SUBDIVISION REVIEW SHEET

CASE NO.: C8-2011-0038.0A

SUBDIVISION NAME: Resubdivision of Lot 2 and a Portion of Lot 3, J. A. Bowles Subdivision

SUBJECT: Variance Request for J.A. Bowles Subdivision, Resubdivision of Lot 2 and a portion of Lot 3
Subdivision Case No: C8-2011-0038.0A.SH

**RESUBDIVISION OF J.A. BOWLES SUBDIVISION
 LOT 2 & A PORTION OF LOT 3
 VARIANCE EXHIBIT**

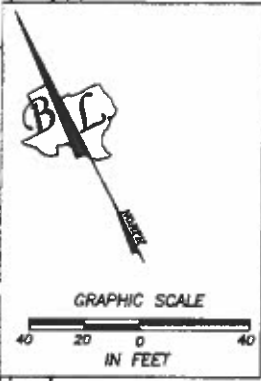
Heritage Trees. Any extension of Gettysburg Drive would necessitate the removal of at least one Heritage Tree (No. 605 - 31" Cedar Elm), due to the required culvert and street construction within the half-critical root zone of the tree (see attached exhibit). The roadway extension would provide no meaningful connectivity for the single lot subdivision unless additional Heritage Trees were removed (Nos. 633 - 30" Live Oak; 665 - 33" Live Oak). Construction of a cul de sac, rather than a street extension, would result in removal of several large trees in the area in addition to Tree No. 605.

NOTE:
 Existing street 3' above natural ground;
 extension would require 5' of fill to
 accommodate box culvert. Grading outside
 ROW or wall required; either would require
 removal of Tree No. 605.
